DOVER PLANNING BOARD – AGENDA

Meeting Type: Regular Meeting
Meeting Location: Council Chambers, City Hall, 288 Central Ave, Dover NH 03820
Meeting Date: **Tuesday, January 22, 2019**
Meeting Time: **7:00 pm**

Application Type: Site Plan Review
Applicant(s): DMC Real Estate Holdings, LLC
Owner(s): Kevin & Lydia Cooper
Location: 67 Knox Marsh Road (Tax Map H, Lot 33)
Date: November 29, 2018

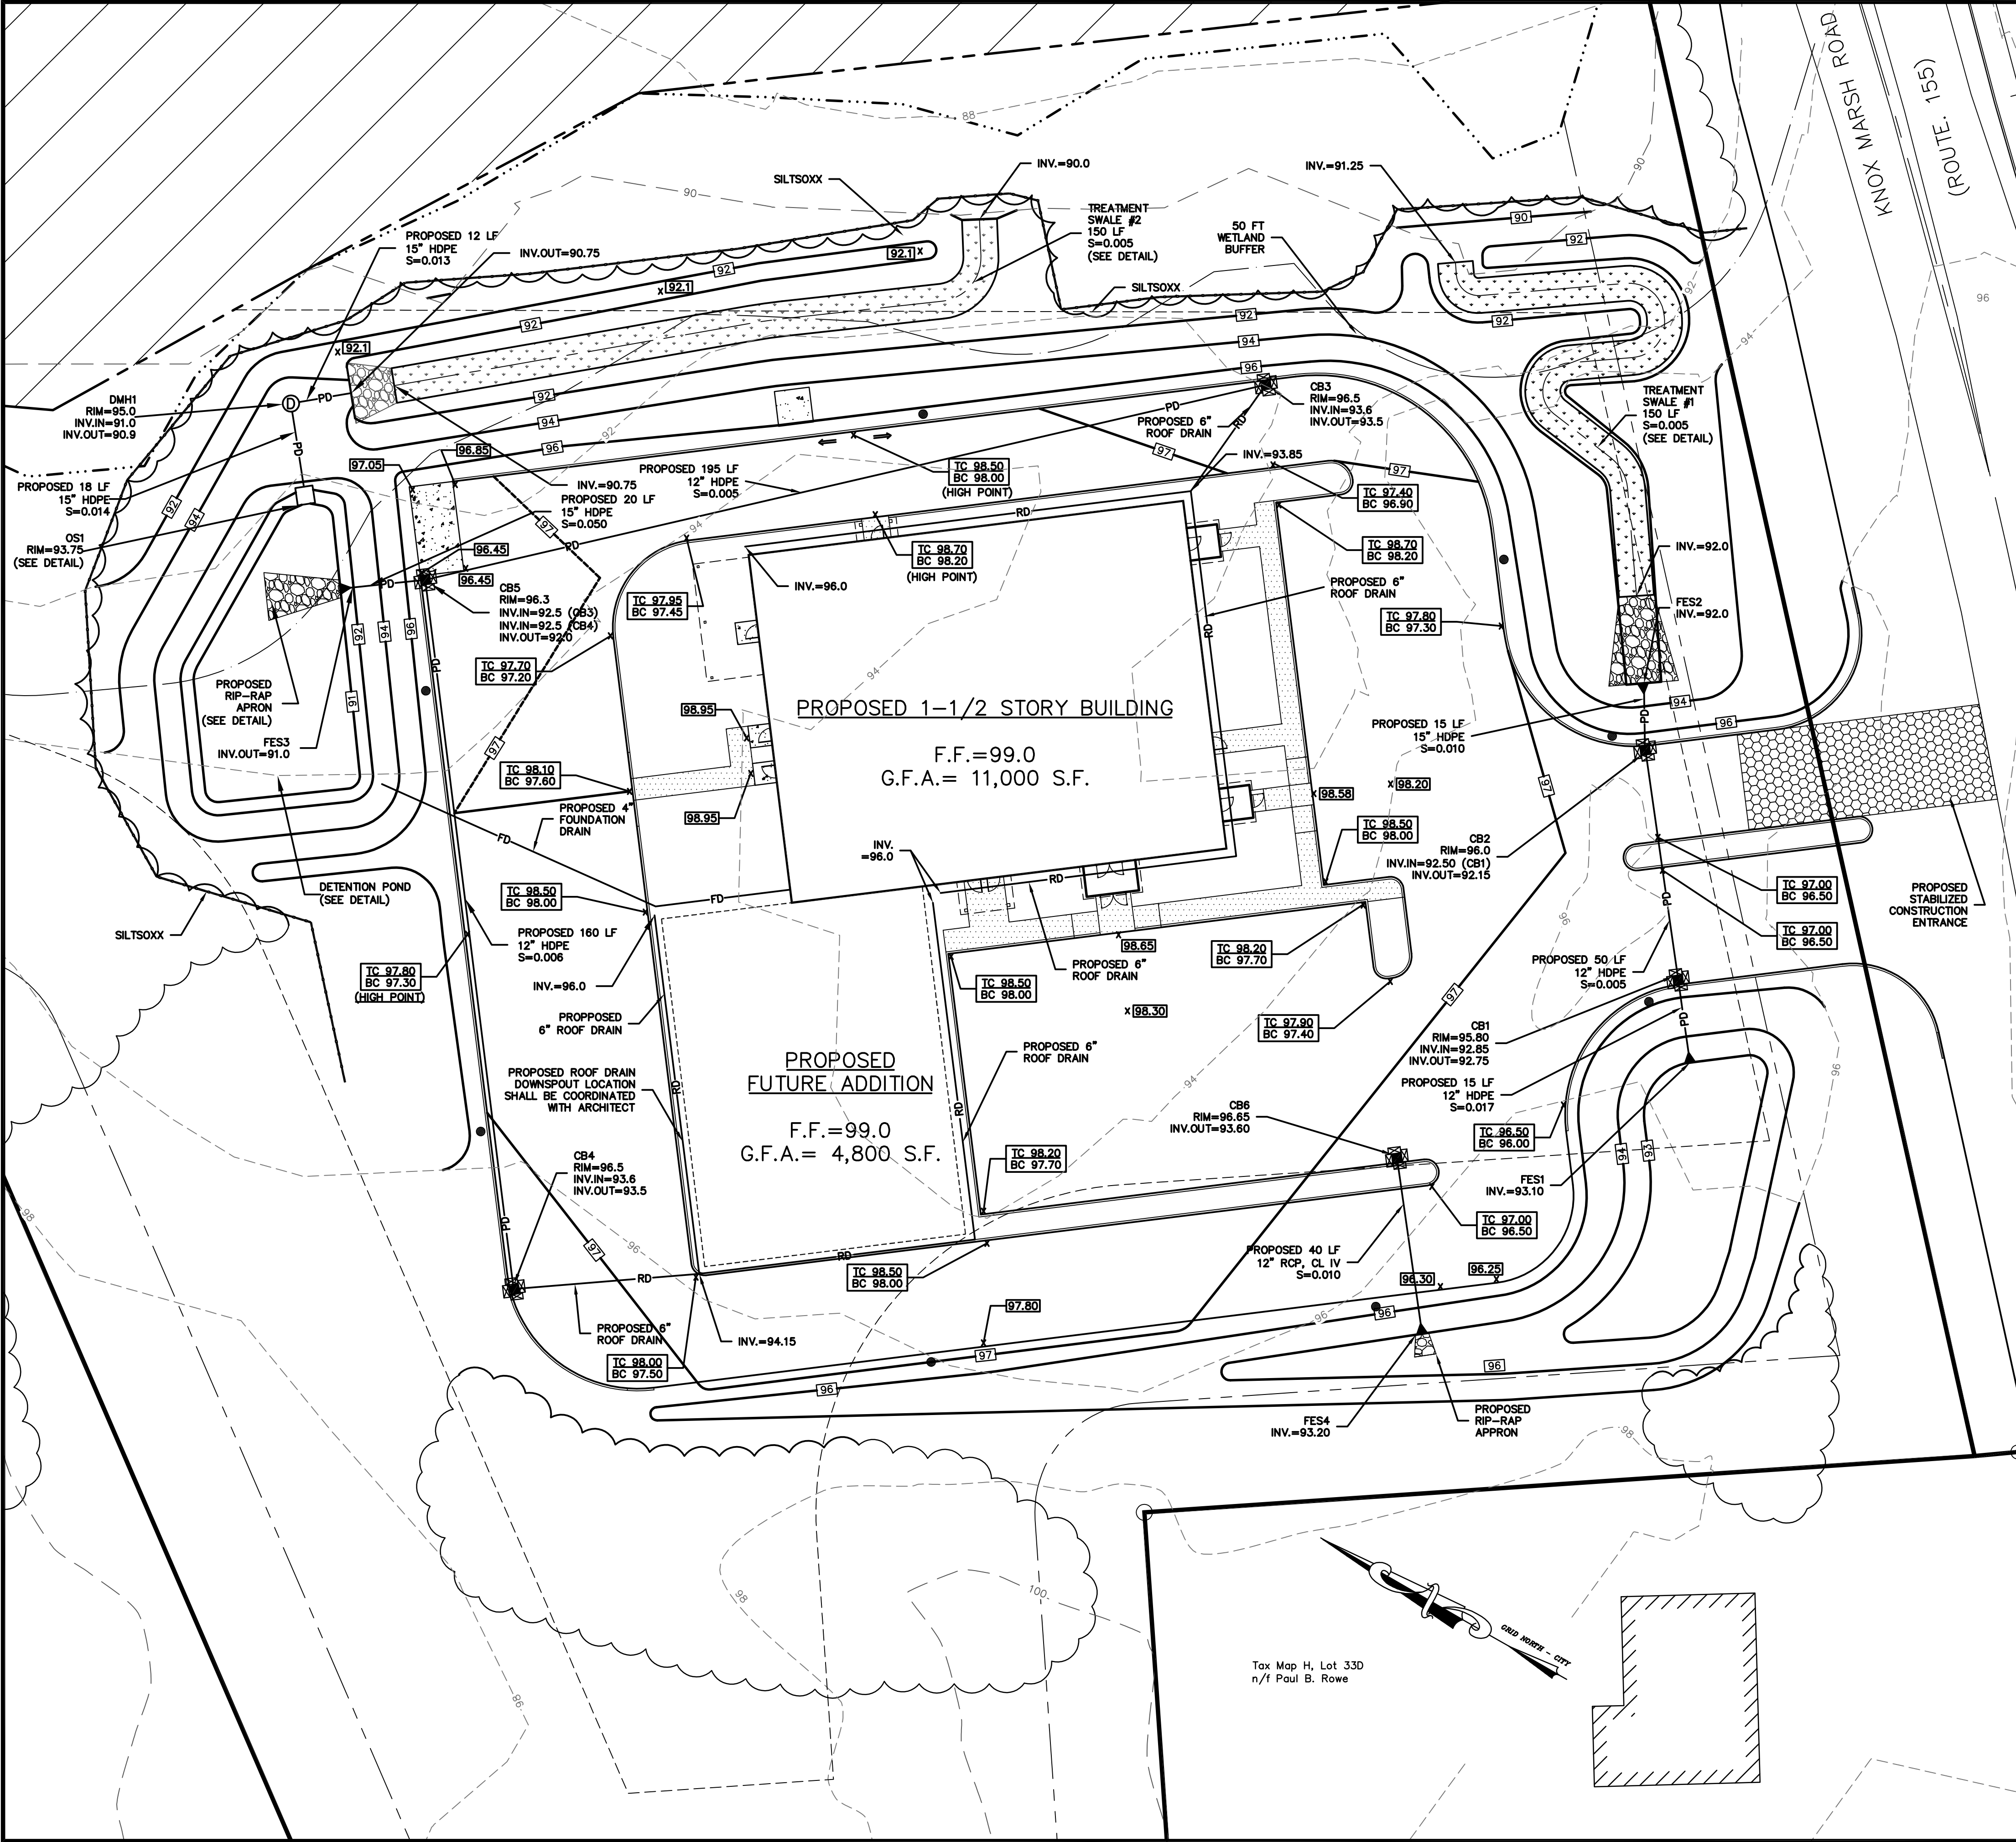
- Switch orientation on sheet 4
 - Comply with visual buffer
 - Clear up/label setback lines on sheets 4 & 5
 - Provide detail of R6-1 sign proposed
 - Pylon sign must be low planter or monument type

- The zoning table has been updated on sheet 4 of the plan set.
- The orientation of the existing conditions plan is now consistent throughout the plan set.

2 RIGHT SIDE ELEVATION
A2.0 Scale: 1/8" = 1'

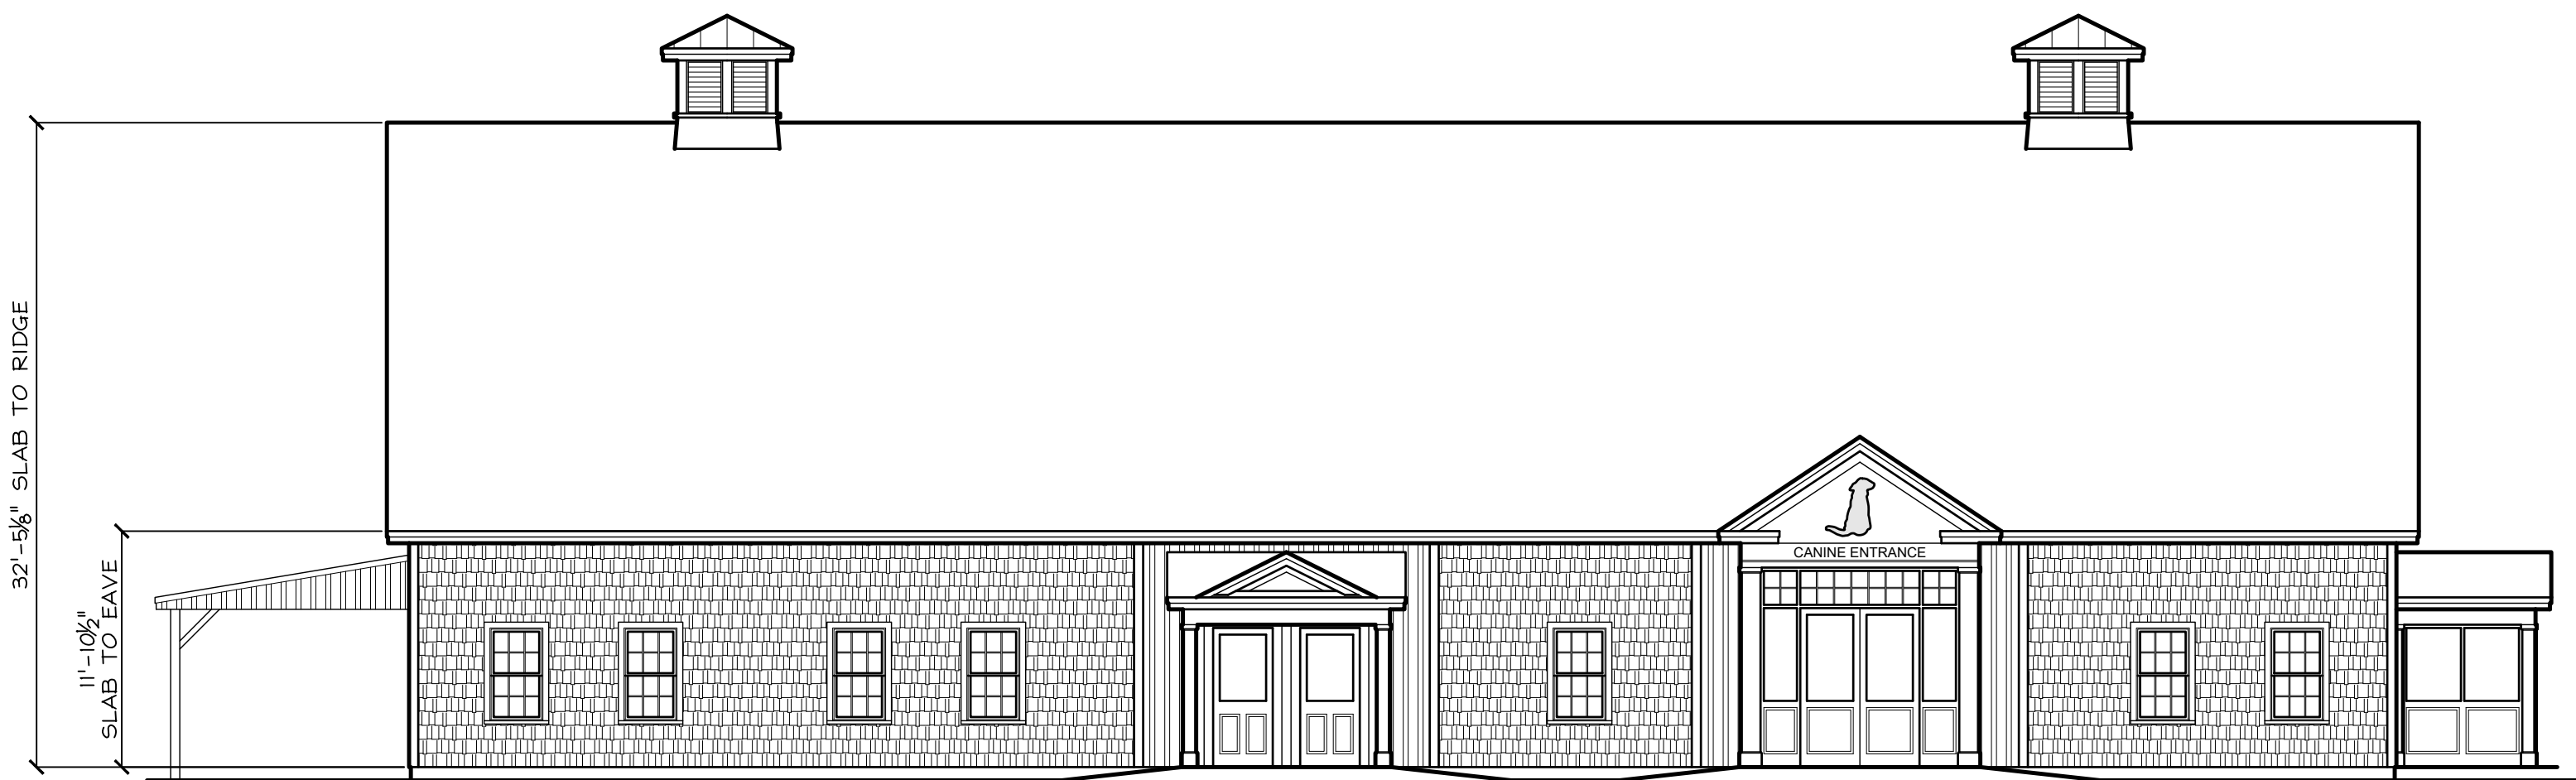
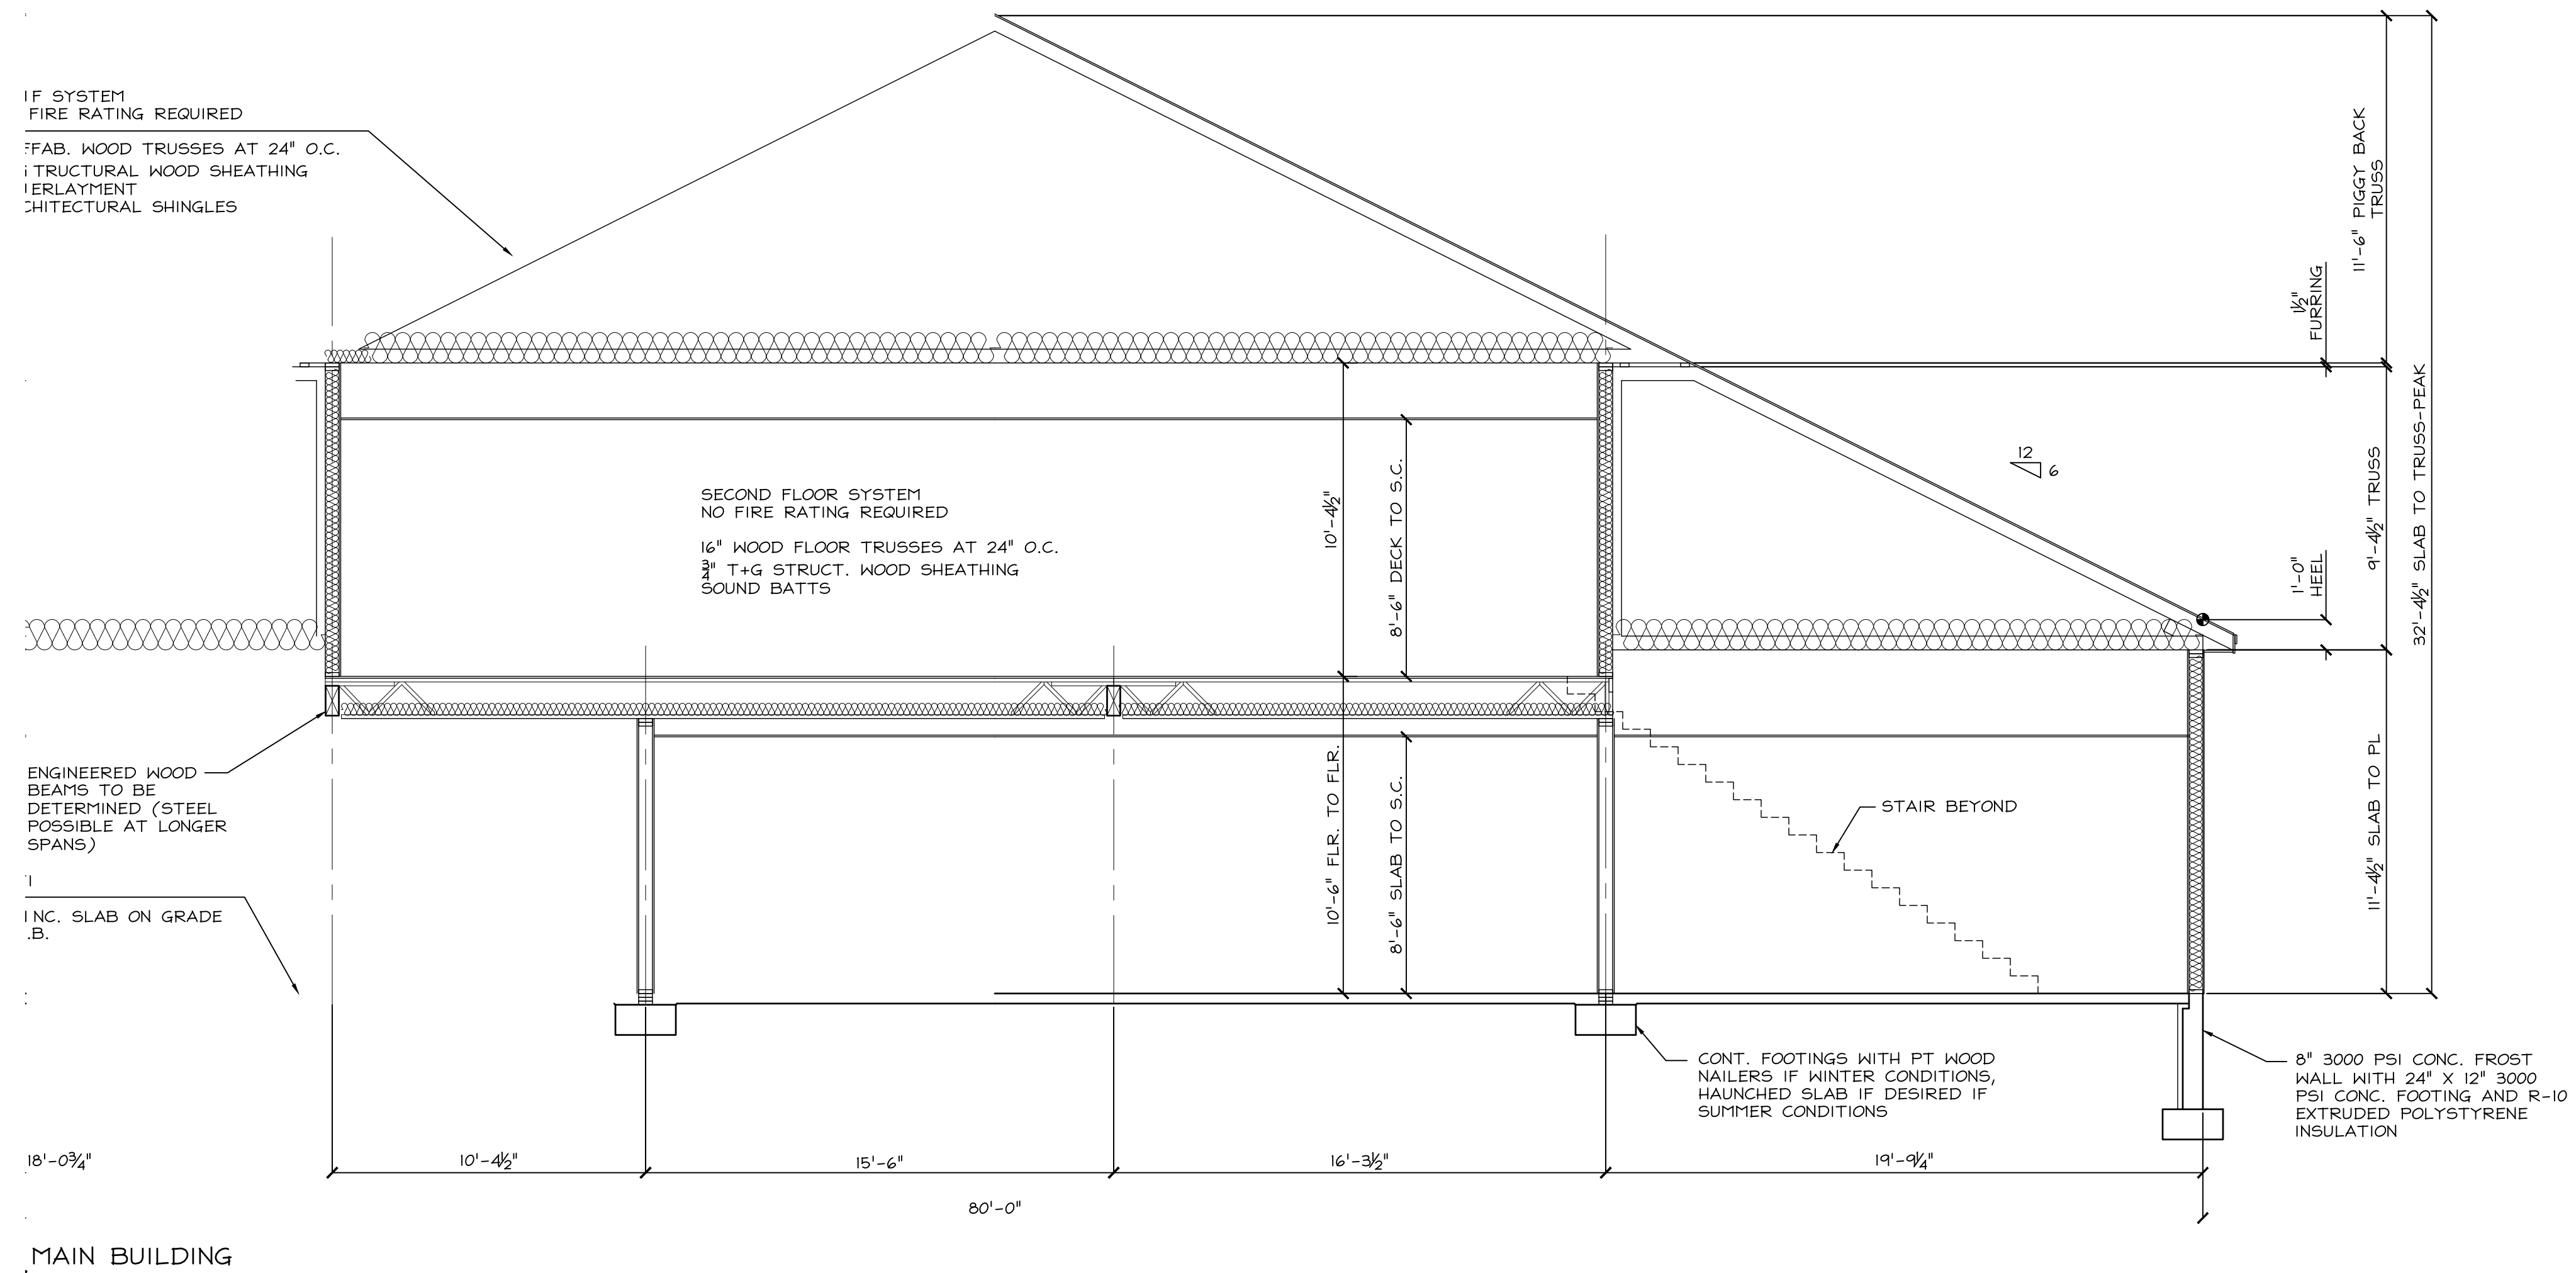
- Indicate materials on Elevations and show full side (fix cut off)
 - Add permit numbers
 - Indicate zoning district boundaries

- A note has been added to the site plan indicating that the pylon sign must be low planter or monument type.
- The building elevation drawings have been updated and are included in the plan set.
- A note has been added to plan sheet 4 to indicate the permits required as pending.
- The existing conditions plan has been updated to indicate the zoning boundaries.
- Additional lights have been added to the site to boost light levels near the building and at the site entrance.
- Snow storage areas have been delineated along the south and west sides of the site.
- A note has been added to the note sheet under the site notes that the project proponent shall place wetland buffer placards along the buffer line.
